FAQ 20-05: RBS Unplanned Scram May 2019  
Tentatively Approved

Plant: River Bend Station, Unit 1  
Date of Event: 5/31/2019  
Submittal Date: October 09, 2020  
Licensee contact: Timothy Schenk Tel/email: 225-381-4177 / tschenk@entergy.com  
NRC Contact: Raymond Kumana Tel/email: 817-200-1970 / rkuma94@entergy.com

Performance Indicator: IE04 - Unplanned Scrams with Complications (USwC)

IE04 Unplanned Scrams with Complications – Flowchart  
Figure 2

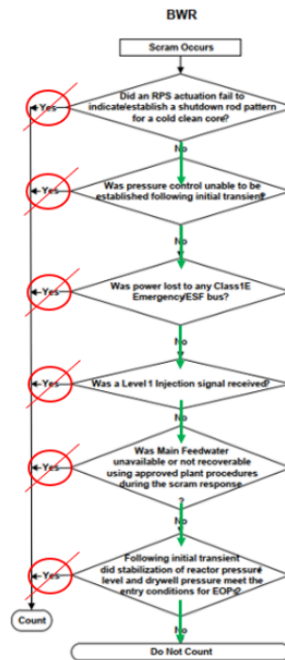
Based upon the above timeline and NEI 99-02 Rev. 7 definitions, RBS was outside the "Scram Response Time" by 30 minutes before the subsequent level three scram signal and therefore did not have an Unplanned Scram with Complications. Additionally, the below flowchart demonstrates this conclusion as seen in NEI 99-02 Rev.7, Figure 2.

*The resident inspectors believe the May 31, 2019 scram is an unplanned scram with complications based on answering “Yes” to NEI 99-01 Revision 7, “IE04 Unplanned Scrams with Complications – Flowchart” questions #5 and #6.*

*On Question #5, “Was main feedwater unavailable or not recoverable using approved plant procedures during the scram response”, the resident believes the answer is “Yes.” The resident takes the word “recoverable” in the sentence to mean recoverable in a sustainable manner. Main feedwater was not recoverable in a sustainable manner using approved plant procedures because approved plant procedures did not instruct operators to un-isolate the heater string when bringing the feed pump back online. In using approved plant procedures, operators failed to un-isolate the heater string during their initial start of the feed pump. Consequently, when they secured the condensate pump per procedure, they caused the feed pump to trip, resulting in a low-level scram signal and an EOP re-entry.*

*On Question #6, “Following initial transient, did stabilization of reactor pressure/level and drywell pressure meet the entry conditions for EOPs?”, NEI 99-02 offers the following clarifying guidance:*

Based on our review, it was determined that the licensee was still in the “Scram Response” window when the second scram occurred and did not meet the ‘and’ condition within the “Scram Response” definition that states in part, *“and concludes when operators have completed the scram response procedures”*, per NEI 99-02, Rev. 7.

In this event, after the licensee experienced the first ‘1A and 1C’ feedwater pump trip on low suction and inserted a manual scram as a response, the operators restarted the ‘C’ feedwater pump, but failed to un-isolate the ‘B’ heater string, which caused the ‘C’ feedwater pump to trip on low suction pressure for a second time. This second ‘C’ feedwater pump trip caused a full RPS actuation on reactor vessel Level 3 and required a second entry to EOP-001, “RPV Control.” The criteria in this question is used to verify that there were no other conditions that developed during stabilization of the plant in the scram response related vessel parameters that required continued operation in the EOPs, re-entry into the EOPs, or transition to a follow-on EOP. Because the operators were attempting to restart the ‘C’ feedwater pump without the correct alignment, which resulted in a second automatic scram and re-entry to EOP-1, the answer to question #6 would be ‘Yes’.

In conclusion, upon reviewing the event details, prior applicable FAQs, and discussing the circumstances surrounding the May 31<sup>st</sup>, 2019 reactor scram, the staff determined that this event should be classified as an Unplanned Scram with Complications (IE03). No changes to NEI 99-02 needed as a result of this FAQ.
